HISTORIC AND DESIGN REVIEW COMMISSION

April 03, 2019

HDRC CASE NO: 2018-531
ADDRESS: 912 DAWSON ST
LEGAL DESCRIPTION: NCB 1370 BLK 2 LOT N 98 FT OF 11
ZONING: RM-4, H
CITY COUNCIL DIST.: 2
DISTRICT: Dignowity Hill Historic District
APPLICANT: Joseph Turner
OWNER: Joseph Turner
TYPE OF WORK: Construction of a two story, multi-family residential structure and a one story, single family residential structure
APPLICATION RECEIVED: March 15, 2019
60-DAY REVIEW: May 14, 2019
CASE MANAGER: Edward Hall
REQUEST:

6 CANOPY FRONT ELEVATION
3/16" = 1'-0"

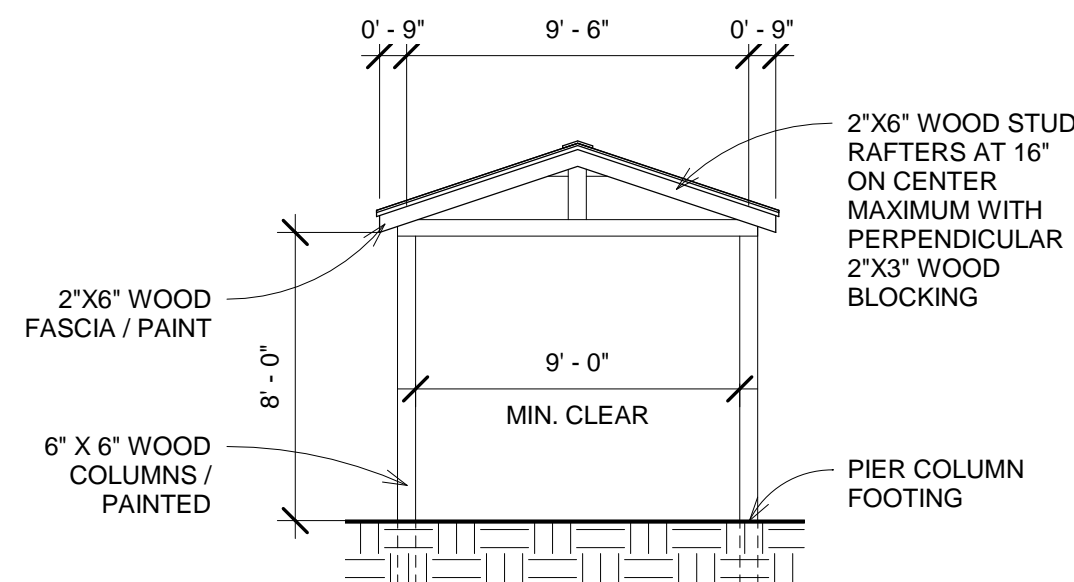
- 3a. Between the two residential structure, the applicant has proposed to construct four, wood framed carports between the two residential structures.
- 3b. DESIGN & CHARACTER – The Guidelines for New Construction 5.A. notes that accessory structures should be designed to be visually subordinate to historic structures, should not be more than forty (40) percent of the primary structure's footprint in size and should feature complementary materials and simplified architectural details. The applicant has proposed standing seam metal roofs and wood columns and beams. The proposed standing seam metal roofs should feature panels that are 18 to 21 inches wide, seams that are 1 to 2 inches tall, a crimped ridge seam or a low profile ridge cap and a standard galvalume finish.

- ii. That all siding feature a smooth finish.
- 3. Staff recommends approval of item #3 based on findings 3a and 3b with the following stipulation:
 - i. That the proposed standing seam metal roof feature panels that are 18 to 21 inches wide, seams that are 1 to 2 inches in height, a crimped ridge seam or a low profile ridge cap and a standard galvalume finish.

1 OVERALL SITE PLAN
1/16" = 1'-0"

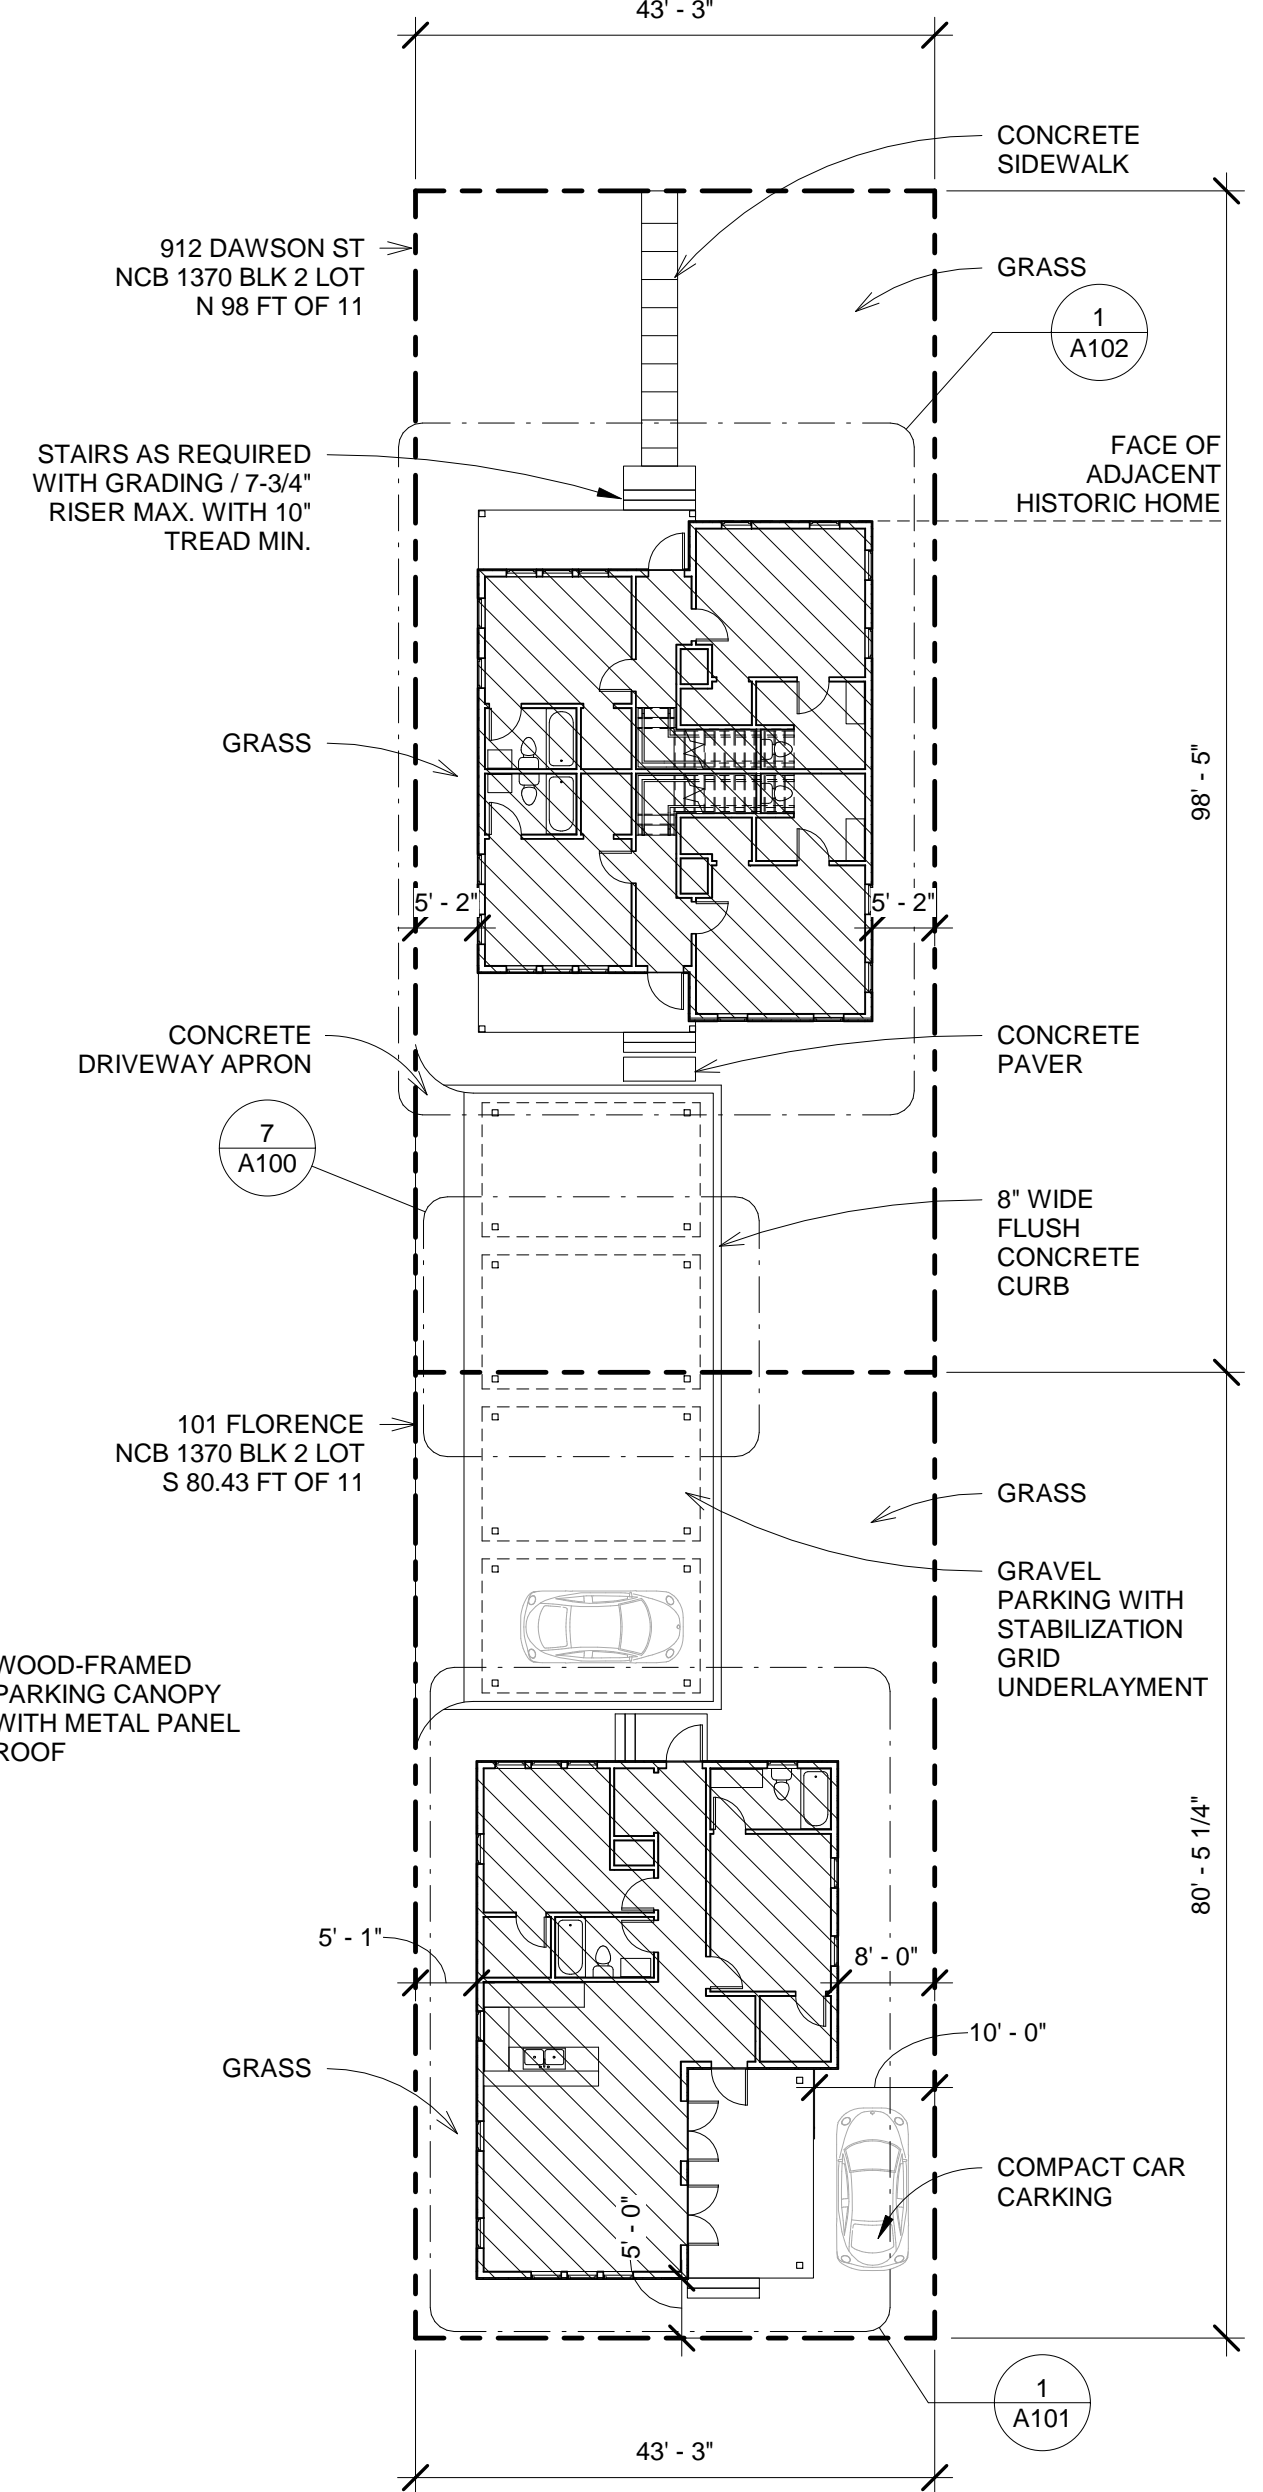
- 1b. SETBACKS & ORIENTATION – According to the Guidelines for New Construction, the front facades of new buildings are to align with front facades of adjacent buildings where a consistent setback has been established along the street frontage. Additionally, the orientation of new construction should be consistent with the historic examples found on the block. The applicant has provided a site plan that notes that the proposed new construction will feature a front façade plane that matches that of the historic structure to the immediate east. The neighboring historic structure features the second deepest setback on this block. That the applicant install a setback on Dawson that is greater than that of the adjacent historic structure. All portions, including porches, should feature a greater setback than the adjacent historic structure’s setback.

- 1. Staff recommends that the applicant address the following items prior to receiving a recommendation for final approval:
 - i. That the applicant install a setback on Dawson that is greater than that of the adjacent historic structure. All portions, including porches, should feature a greater setback than the adjacent historic structure's setback.

1 DUPLEX NORTH ELEVATION
3/16" = 1'-0"

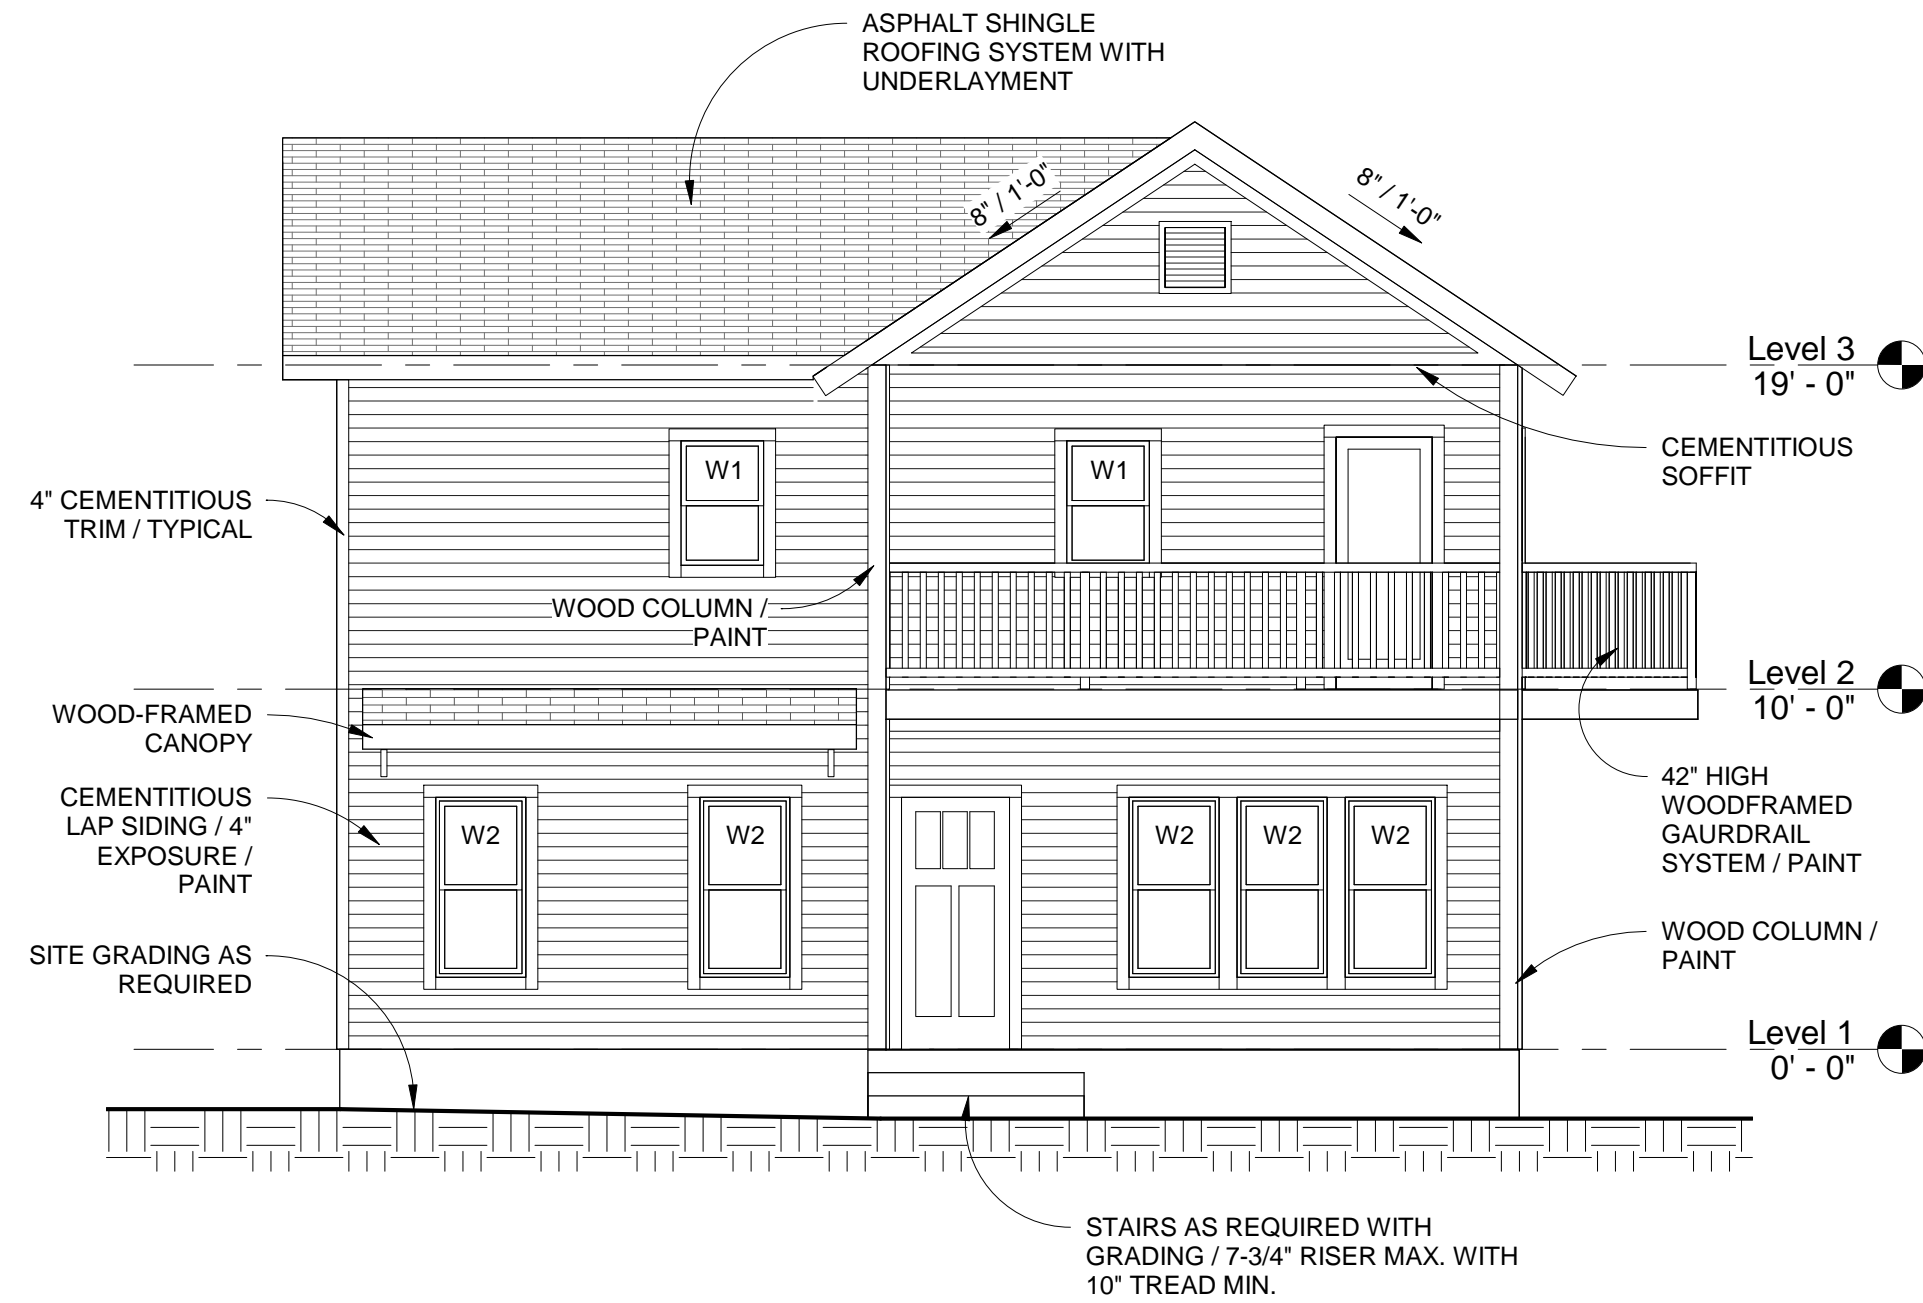
- 1k. **ARCHITECTURAL DETAILS** – The applicant has proposed architectural details that generally feature massing that is consistent with that found historically in the district. The applicant has proposed front facing gabled roofs, double height and recessed front porches. As noted in finding 1j, staff finds that the proposed east elevation should feature additional fenestration. Additionally, staff finds that the proposed cantilevered balconies should feature columns or brackets, that the north and south elevations should feature an additional second story window, that the front and rear porch doors should be centered on the porch steps, and that windows should be centered under roof forms.

- 1l. **ARCHITECTURAL DETAILS (Porches)** – The applicant has proposed a porch depth of four (4) feet. Staff finds that the applicant should increase the proposed porch depth to at least five (5) feet to feature a porch depth more consistent with those found historically on the block.

- iii. That the applicant install additional fenestration to the structure's east, north and south elevations ig and ik as noted in finding ig.
 - iv. That the front and rear doors be centered on the porch steps and that the porch depths be increased to at least five (5) feet.

3 DUPLEX EAST ELEVATION
3/16" = 1'-0"

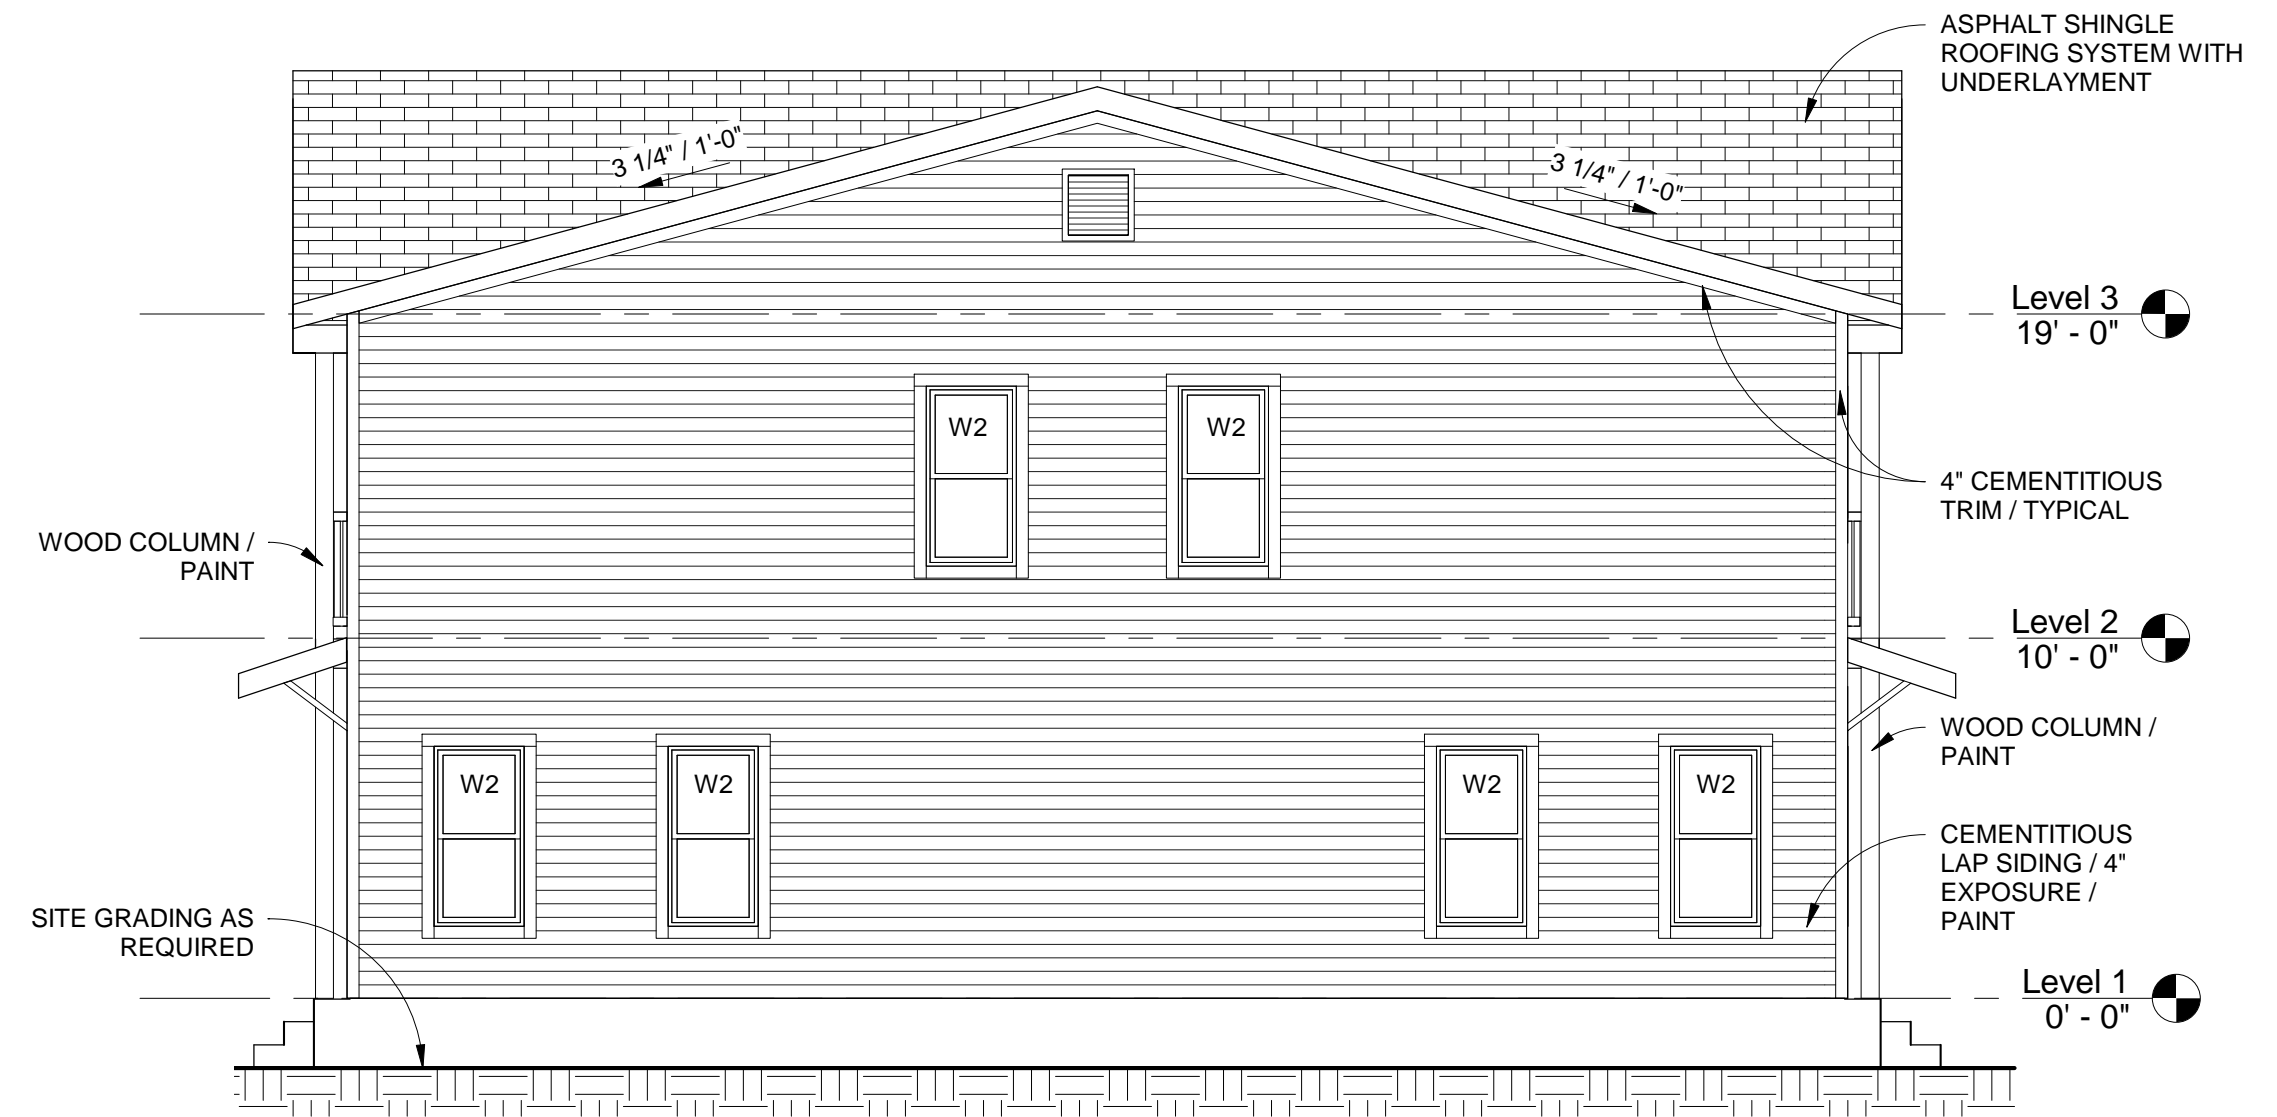
- 1g. **WINDOW & DOOR OPENINGS** – Per the Guidelines for New Construction 2.C.i., window and door openings with similar proportions of wall to window space as typical with nearby historic facades should be incorporated into new construction. Staff finds the proposed window proportions are consistent with the Guidelines and then historic examples found throughout the district; however, staff finds that additional fenestration should be incorporated into the east elevation.
